Product Change Notice

PCN#: EE-PCN26032
September 4, 2026

CLASSIFICATION OF CHANGE:
Certification change

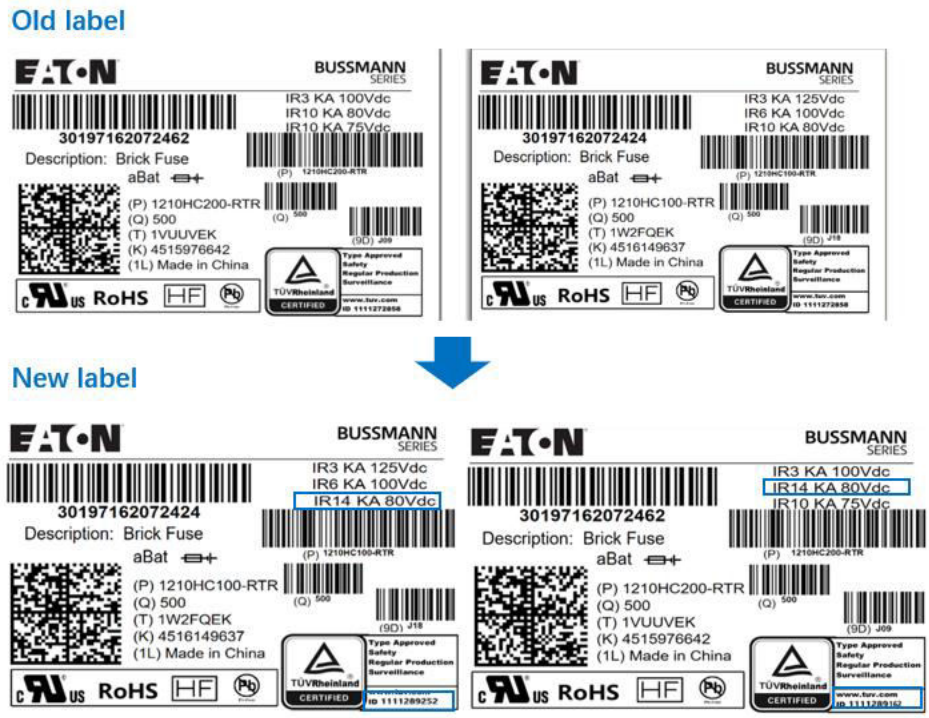
DESCRIPTION OF CHANGE:
The Fuse 1210HC series has upgraded its UL and TUV certifications from an interrupting rating (IR) of 10kA at 80Vdc to 14kA at 80Vdc.

REASON FOR CHANGE:
The 1210HC Fuse Series is now certified for an enhanced interrupting rating of 14kA @ 80Vdc under both UL and TUV certifications, upgraded from the previous 10kA @ 80Vdc rating. Packaging labels have been updated accordingly, as shown below.
